CITY PLAN COMMISSION STAFF REPORT

CD-CPC-2025-00075

Linwood & Troost MPD Residential

August 20, 2025

PROPOSED SITE PLAN

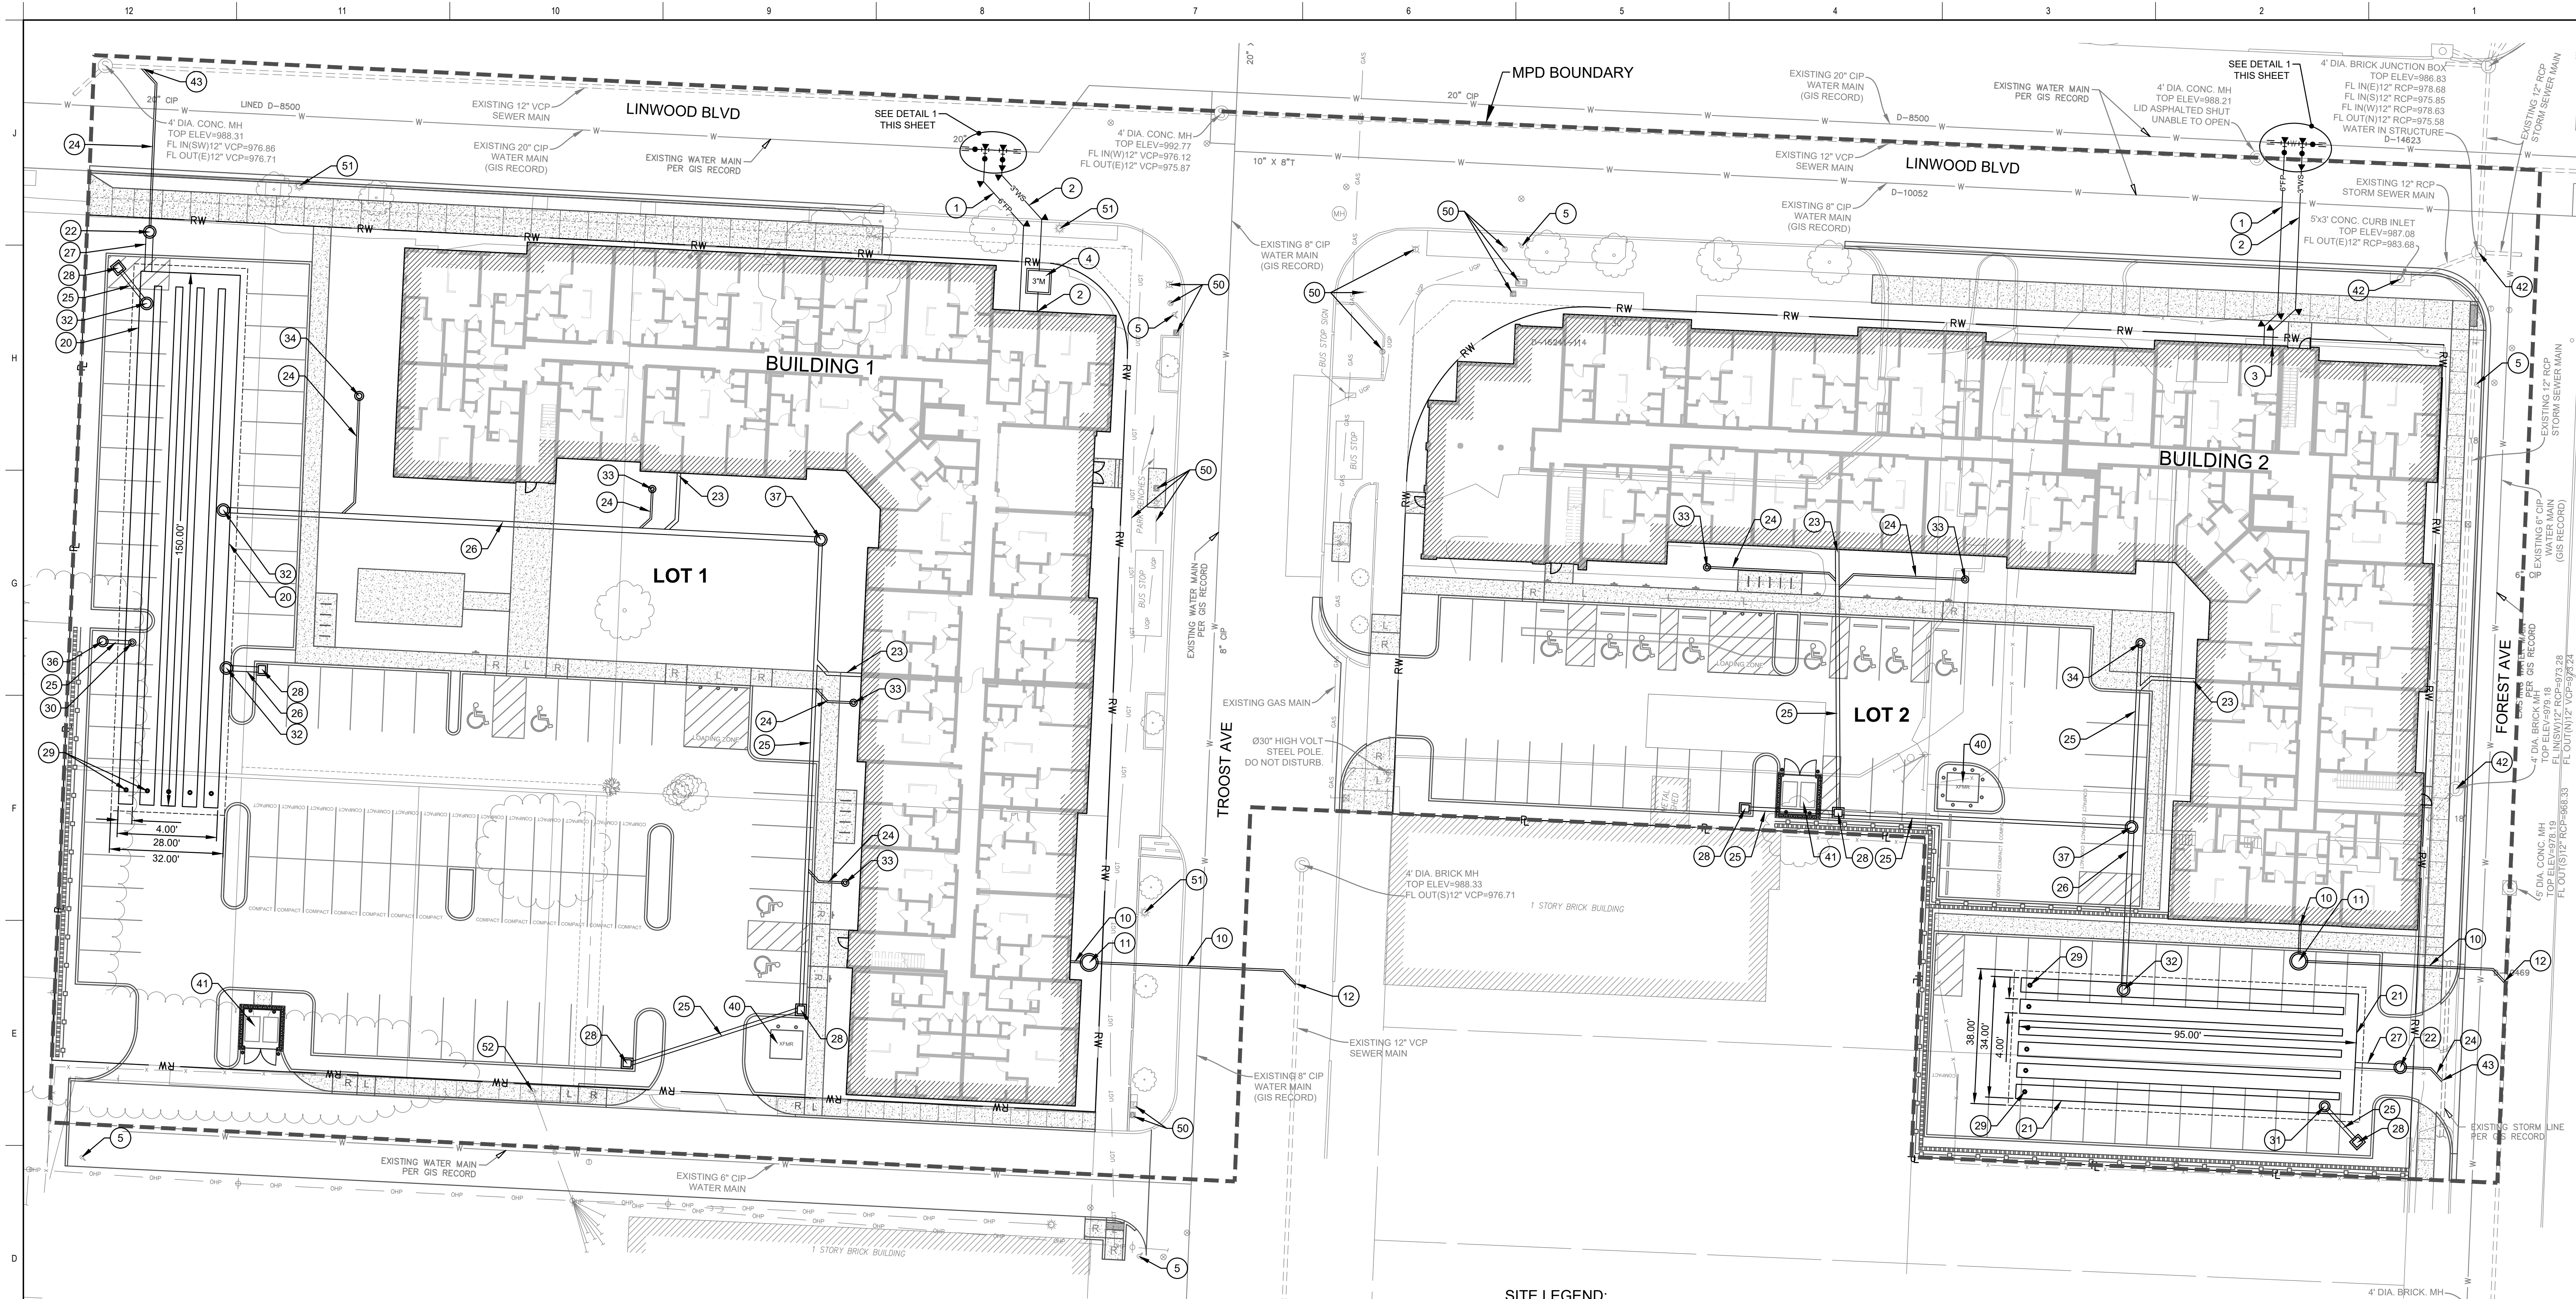
18. • The turning radius for fire department access roads shall be 30 feet inside and 50 feet outside radius. (IFC-2018: § 503.2.4) • Fire hydrants shall be installed and operable prior to the arrival of any combustible building materials onto the site. (IFC-2018 § 501.4 and 3312.1; NFPA 241-2013 § 8.7.2)

- Shall provide truck turning templates within the drive and parking lot (IFC-2018 § 503.2.4).
19. • Fire hydrants shall be installed and operable prior to the arrival of any combustible building materials onto the site. (IFC-2018 § 501.4 and 3312.1; NFPA 241-2013 § 8.7.2)
